TVA-BFN-TS-441

**BROWNS FERRY NUCLEAR PLANT (BFN) - UNITS 2 and 3 - TECHNICAL SPECIFICATIONS (TS) CHANGE TS-441 - UPDATE OF PRESSURE-TEMPERATURE (P-T) CURVES**

#### PROPOSED TECHNICAL SPECIFICATIONS (TS) CHANGE TS-441 TVA EVALUATION OF PROPOSED CHANGE

**Figure 3.4.9-1  
Pressure/Temperature Limits**

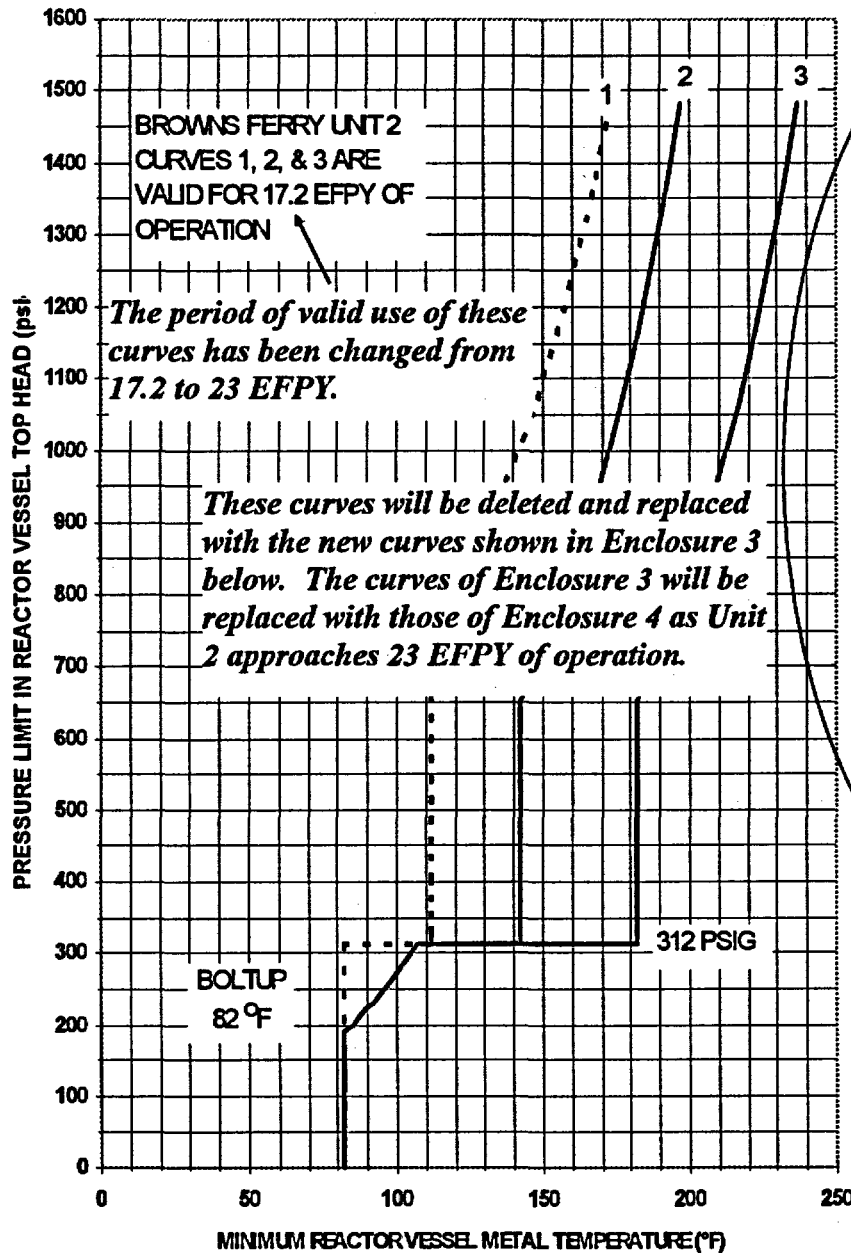
Curve Legends have been revised on new TS pages to include the additional curves, their applicability, and the new Unit 2 valid EFPY interval of 23 years

These curves include sufficient margin to provide protection against feedwater nozzle degradation. The curves allow for shifts in  $RT_{NDT}$  of the Reactor vessel bellline materials, in accordance with Reg. Guide 1.99, Rev. 2, to compensate for radiation embrittlement for 17.2 EFPY.

**Figure 3.4.9-1  
Pressure/Temperature Limits**

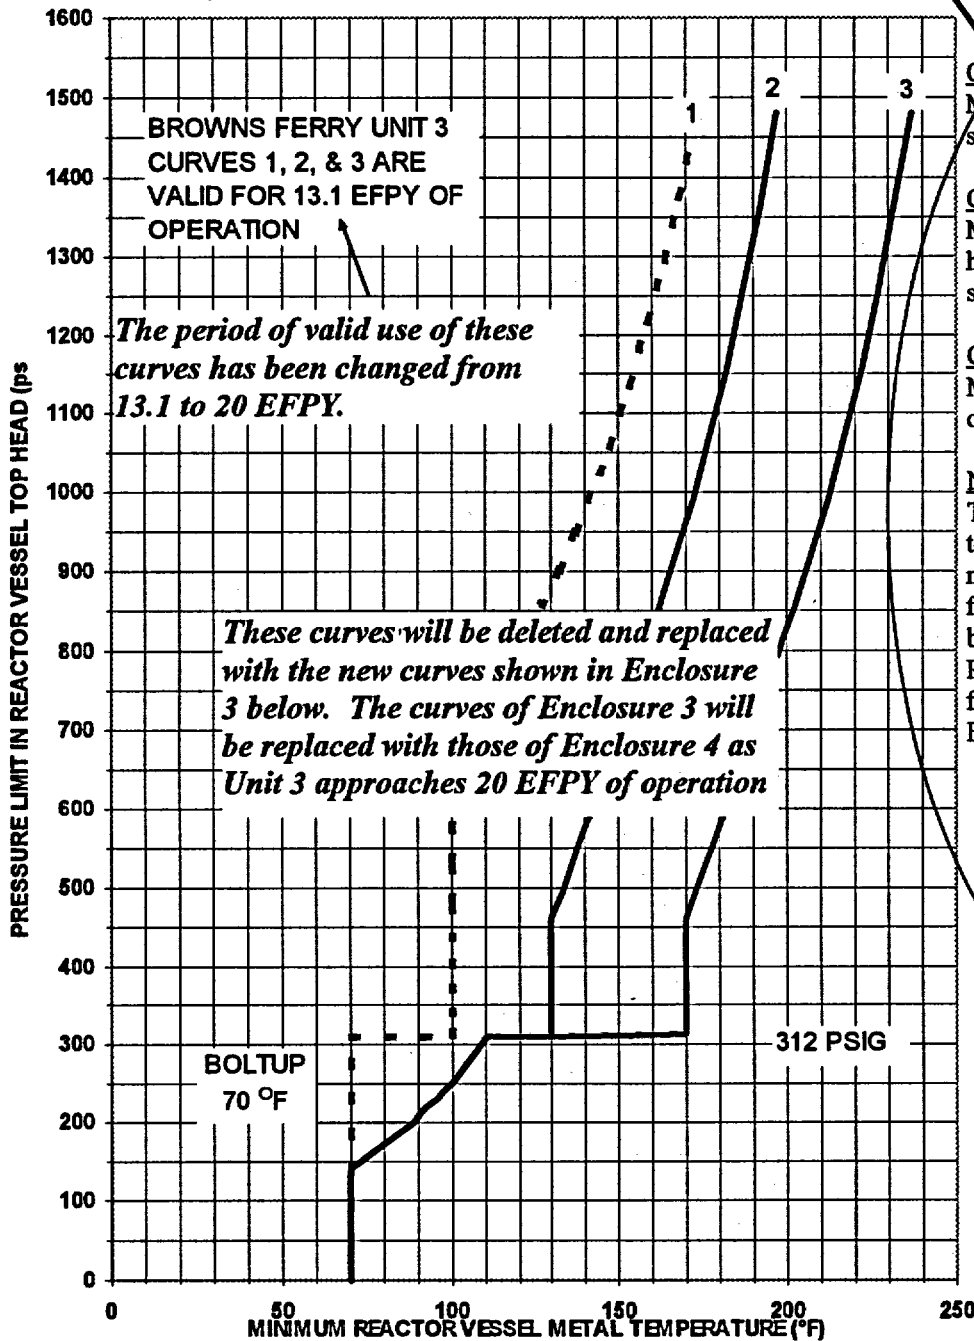
Curve Legends have been revised on new TS pages to include the additional curves, their applicability, and the new Unit 3 valid EFPY interval of 20 years

**Notes**  
These curves include sufficient margin  
to provide protection against feedwater  
nozzle degradation. The curves allow  
for shifts in  $RT_{NDT}$  of the Reactor vessel  
beltline materials, in accordance with  
Reg. Guide 1.99, Rev. 2, to compensate  
for radiation embrittlement for 13.1  
EFPY.

**Figure 3.4.9-1**  
**Pressure/Temperature Limits for**  
**Mechanical Heatup, Cooldown following Shutdown, and**  
**Reactor Critical Operations**

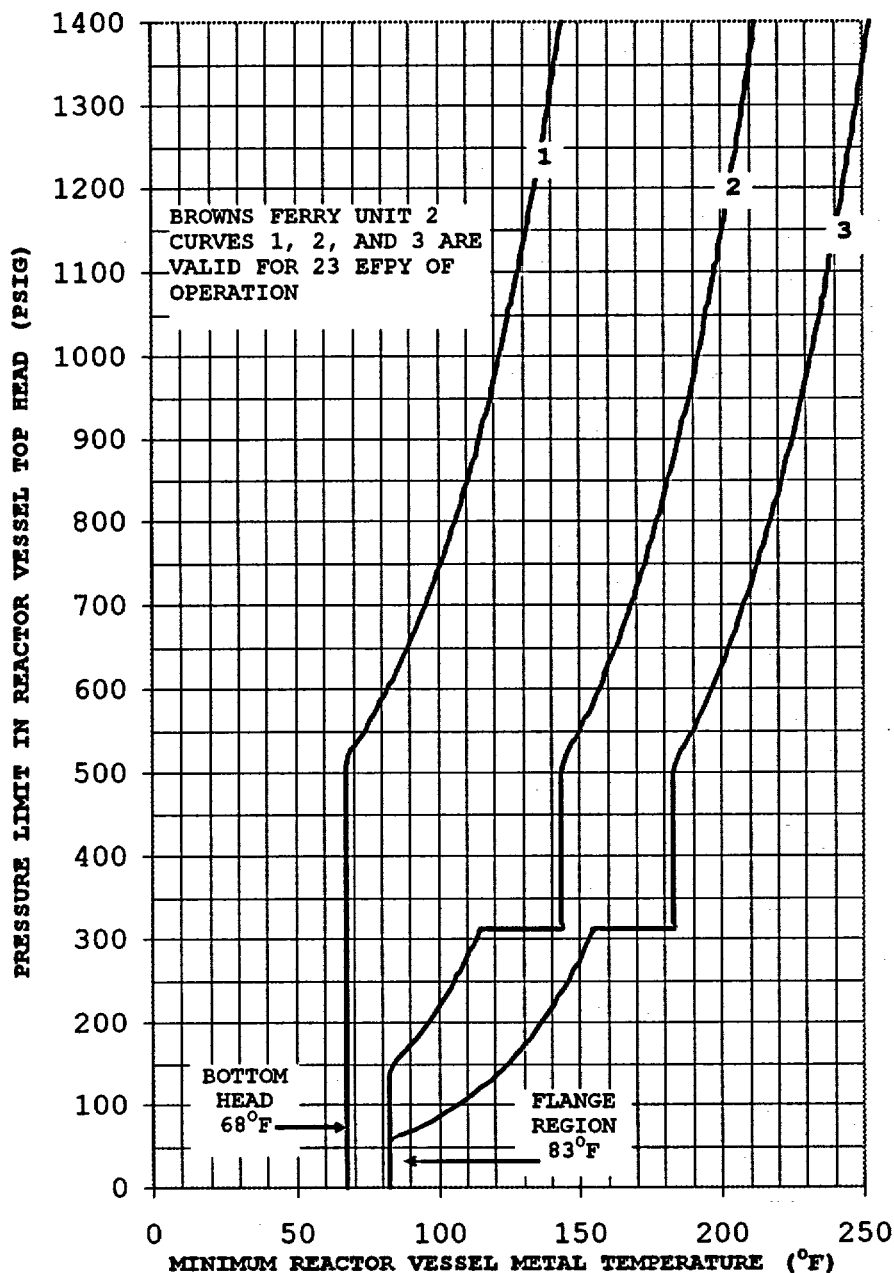
Curve No. 1  
Minimum temperature for  
bottom head during  
mechanical heatup or  
cooldown following nuclear  
shutdown.

Curve No. 2  
Minimum temperature for  
upper RPV and beltline  
during mechanical heatup  
or cooldown following  
nuclear shutdown.

Notes  
These curves include  
sufficient margin to  
provide protection against  
feedwater nozzle  
degradation. The curves  
allow for shifts in  $RT_{NDT}$   
of the Reactor vessel  
beltline materials, in  
accordance with Reg. Guide  
1.99, Rev. 2, to  
compensate for radiation  
embrittlement for 23 EFPY.

**Figure 3.4.9-2**  
**Pressure/Temperature Limits for**  
**Reactor In-Service Leak and Hydrostatic Testing**

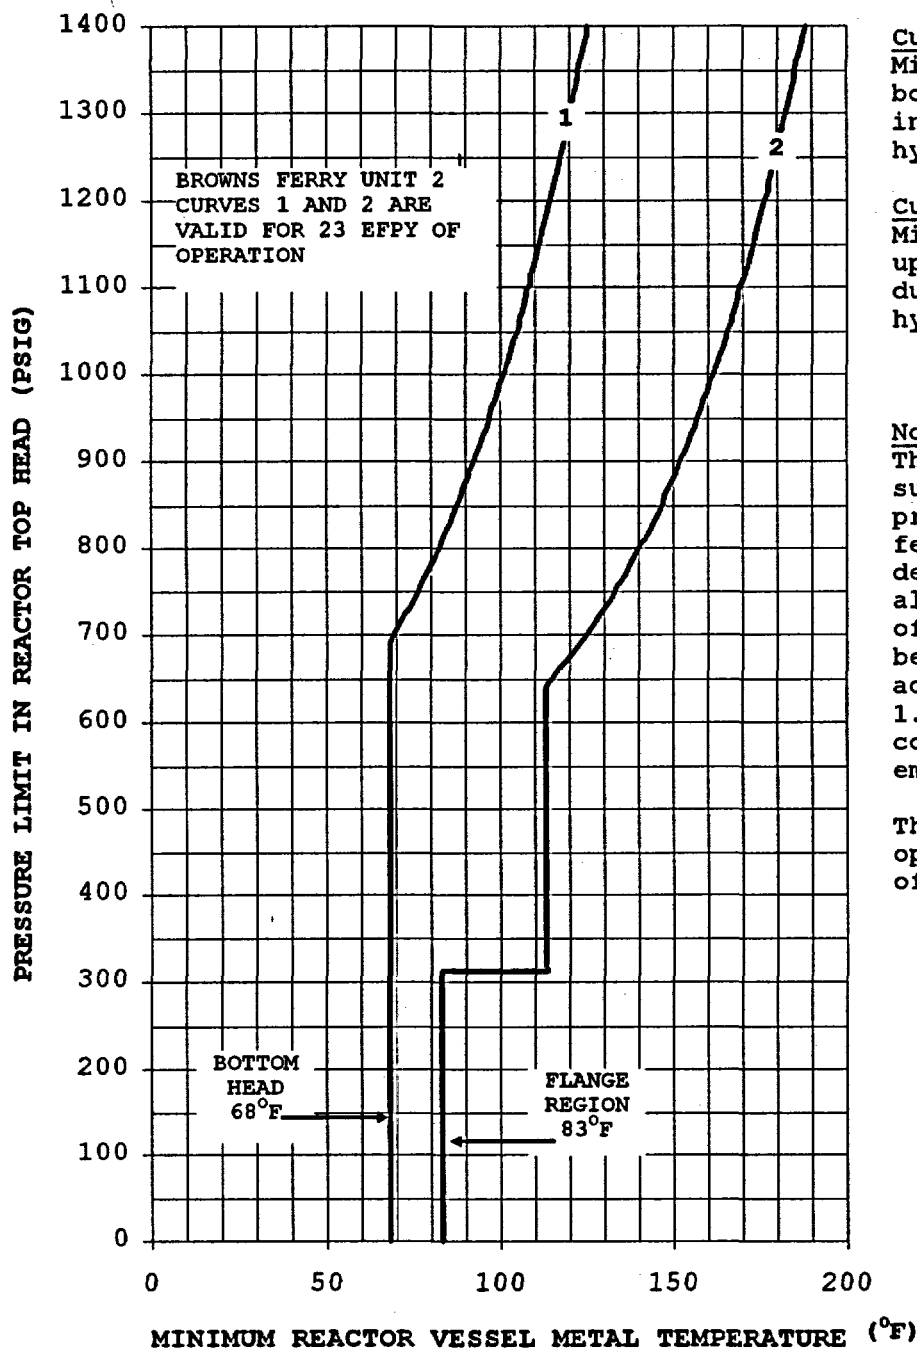
1. TS Figure 3.4.9-1 for Unit 2 and Unit 3 is deleted and replaced in its entirety.
2. The new TS Figure 3.4.9-1 contains an added curve which specifically details reactor vessel bottom head temperature versus pressure limitations for non-critical heatup/cooldown operational conditions.
3. A new TS Figure 3.4.9-2 has been added which contains curves for the reactor vessel bottom head and the upper vessel/beltline regions for in-service leak and hydrostatic testing activities.

**Figure 3.4.9-1**  
**Pressure/Temperature Limits for**  
**Mechanical Heatup, Cooldown following Shutdown, and**  
**Reactor Critical Operations**

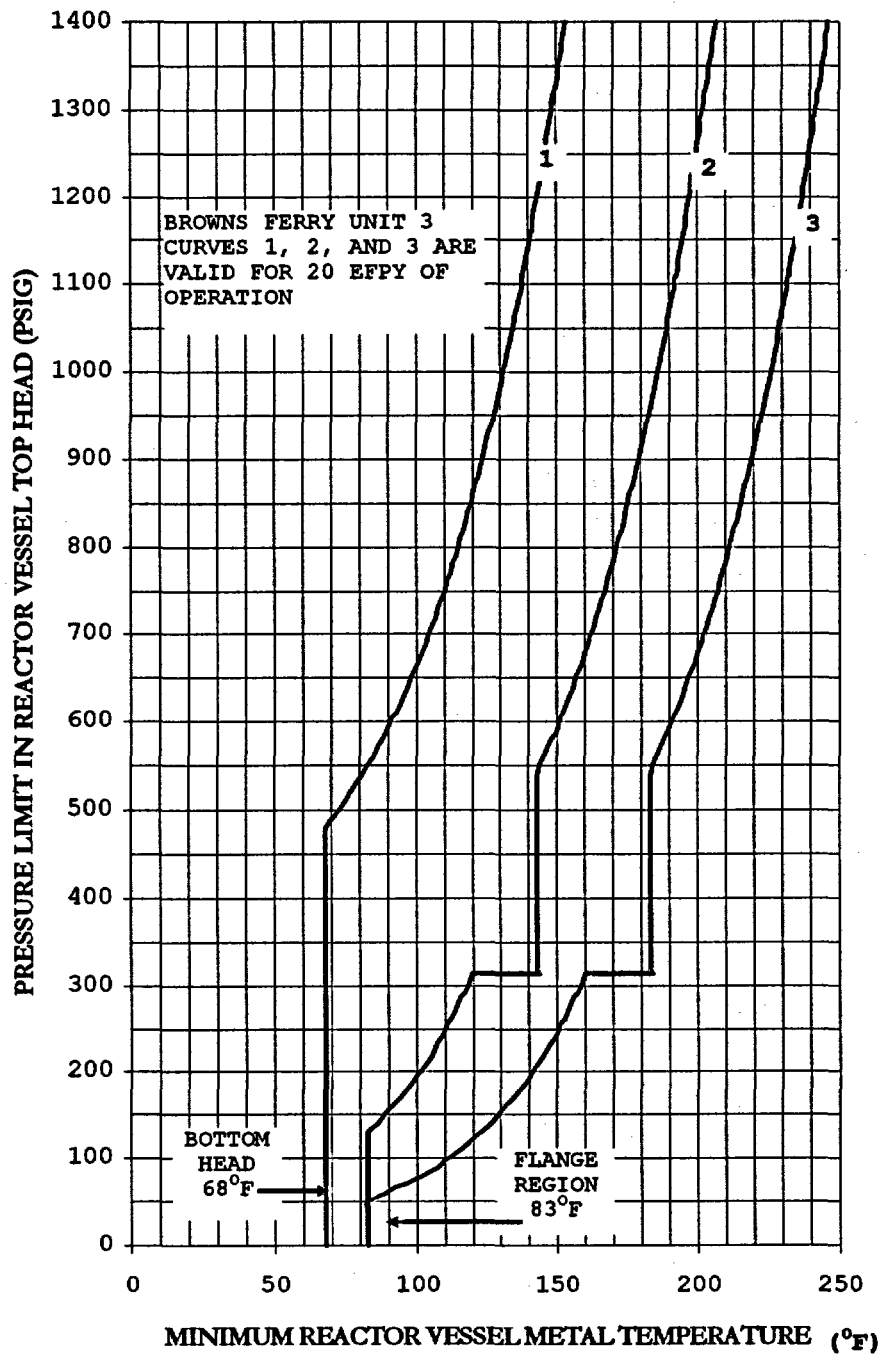
Curve No. 1  
Minimum temperature for  
bottom head during  
mechanical heatup or  
cooldown following nuclear  
shutdown.

Curve No. 2  
Minimum temperature for  
upper RPV and beltline  
during mechanical heatup  
or cooldown following  
nuclear shutdown.

Notes  
These curves include  
sufficient margin to  
provide protection against  
feedwater nozzle  
degradation. The curves  
allow for shifts in  $RT_{NDT}$   
of the Reactor vessel  
beltline materials, in  
accordance with Reg. Guide  
1.99, Rev. 2, to  
compensate for radiation  
embrittlement for 20 EFY.

**Figure 3.4.9-1**  
**Pressure/Temperature Limits for Mechanical Heatup, Cooldown following Shutdown, and Reactor Critical Operations**

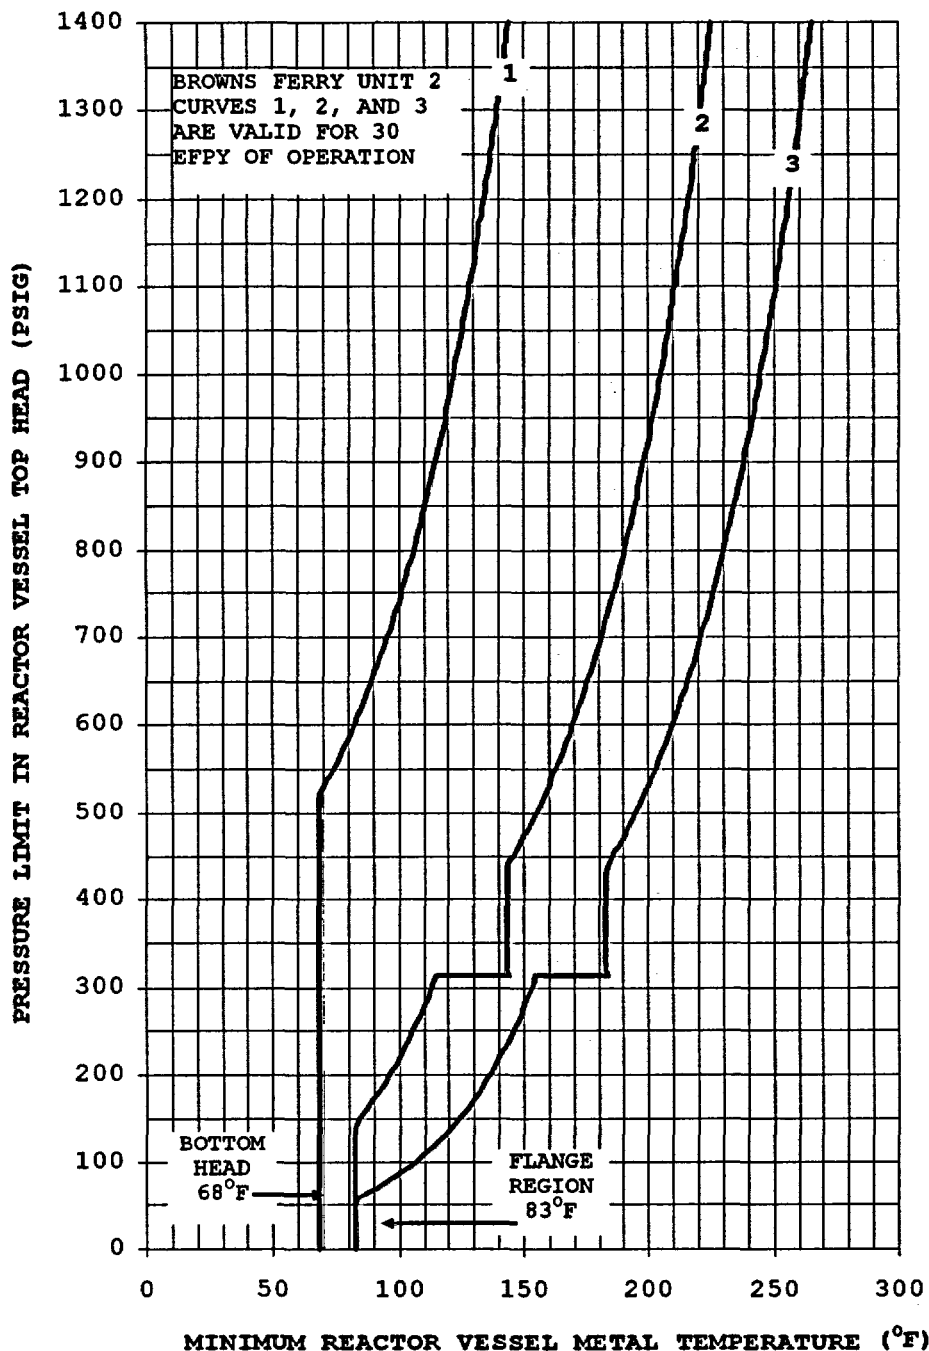
These pages are submitted for NRC review and approval, however, they will not be placed into the BFN TS at this time. As Unit 2 approaches 23 EFPY, and as Unit 3 approaches 20 EFPY, TVA will replace the TS figures shown in Enclosure 3 above with these figures.

Curve No. 1  
Minimum temperature for bottom head during mechanical heatup or cooldown following nuclear shutdown.

Curve No. 2  
Minimum temperature for upper RPV and beltline during mechanical heatup or cooldown following nuclear shutdown.

Notes  
These curves include sufficient margin to provide protection against feedwater nozzle degradation. The curves allow for shifts in  $RT_{NDT}$  of the Reactor vessel beltline materials, in accordance with Reg. Guide 1.99, Rev. 2, to compensate for radiation embrittlement for 30 EFPY.

**Figure 3.4.9-2**  
**Pressure/Temperature Limits for**  
**Reactor In-Service Leak and Hydrostatic Testing**

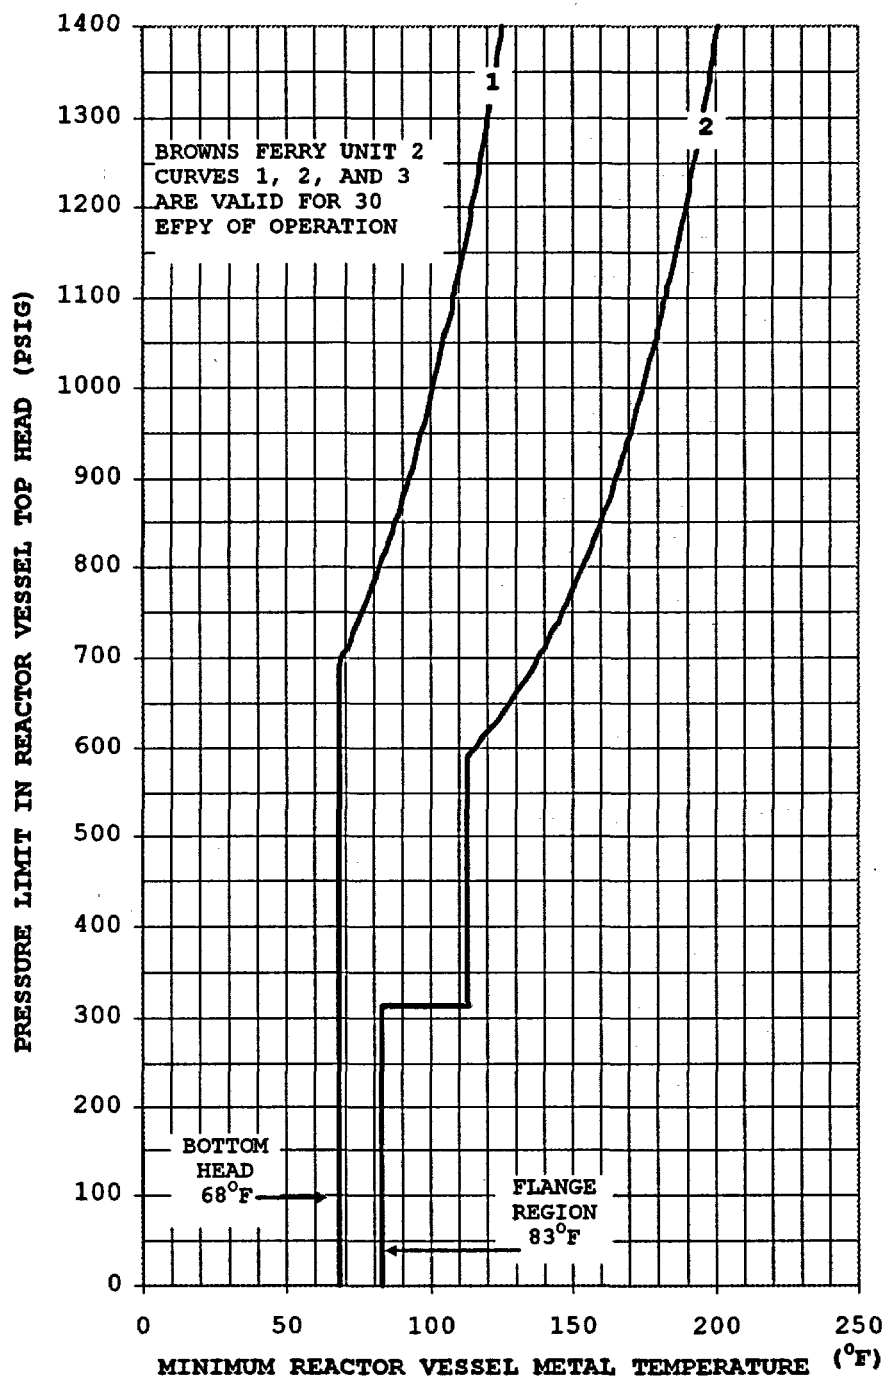
Curve No. 1  
Minimum temperature for  
bottom head during  
in-service leak or  
hydrostatic testing.

Curve No. 2  
Minimum temperature for  
upper RPV and beltline  
during in-service leak or  
hydrostatic testing.

Notes  
These curves include  
sufficient margin to  
provide protection against  
feedwater nozzle  
degradation. The curves  
allow for shifts in  $RT_{NDT}$   
of the Reactor vessel  
beltline materials, in  
accordance with Reg. Guide  
1.99, Rev. 2, to  
compensate for radiation  
embrittlement for 30 EFPY.

**Figure 3.4.9-1**  
**Pressure/Temperature Limits for Mechanical**  
**Heatup, Cooldown following Shutdown, and**  
**Reactor Critical Operations**

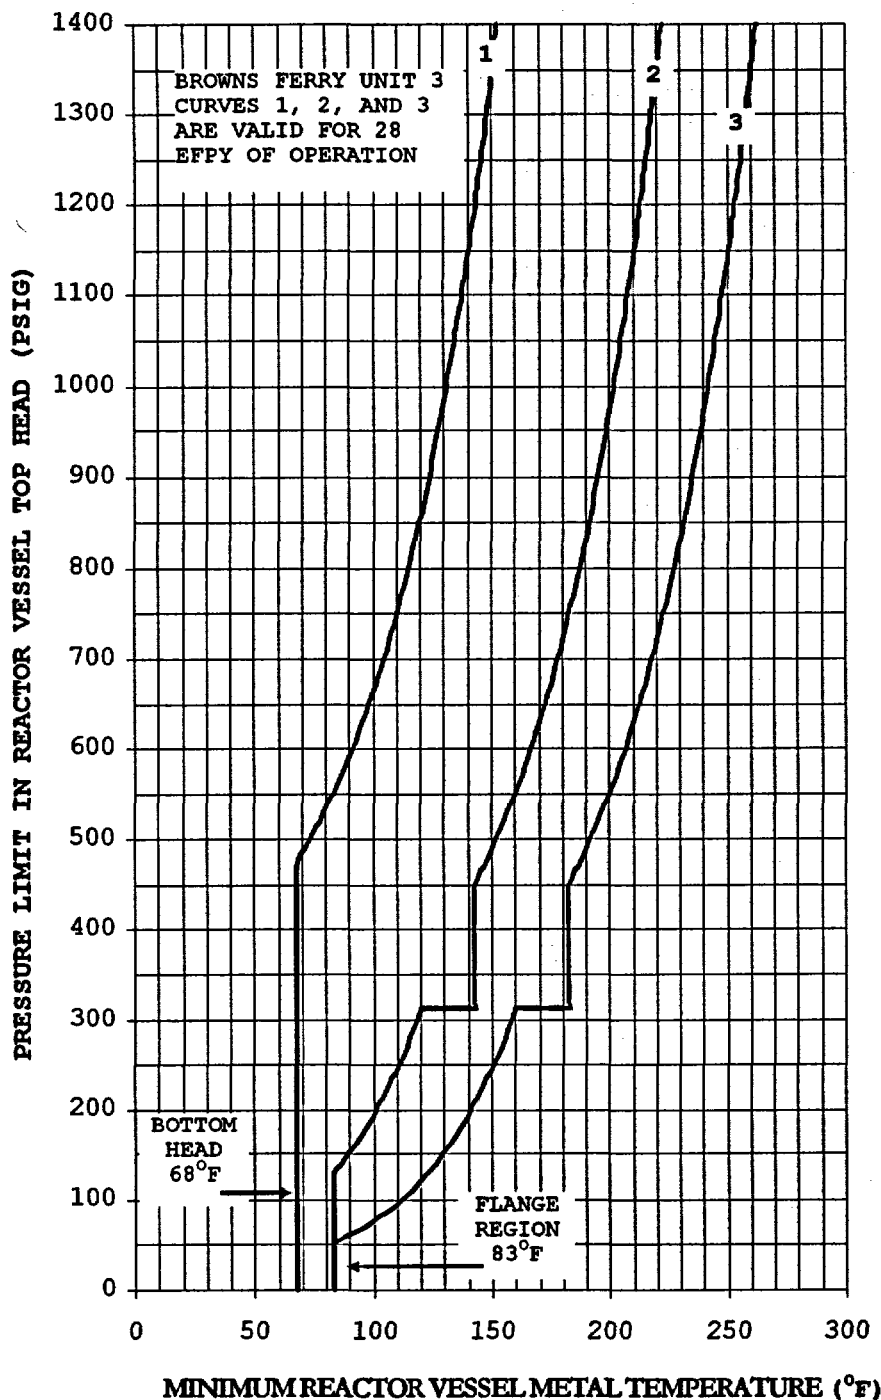
Curve No. 1  
Minimum temperature for  
bottom head during  
mechanical heatup or  
cooldown following nuclear  
shutdown.

Curve No. 2  
Minimum temperature for  
upper RPV and beltline  
during mechanical heatup  
or cooldown following  
nuclear shutdown.

Notes  
These curves include  
sufficient margin to  
provide protection against  
feedwater nozzle  
degradation. The curves  
allow for shifts in  $RT_{NDT}$   
of the Reactor vessel  
beltline materials, in  
accordance with Reg. Guide  
1.99, Rev. 2, to  
compensate for radiation  
embrittlement for 28 EFPY.
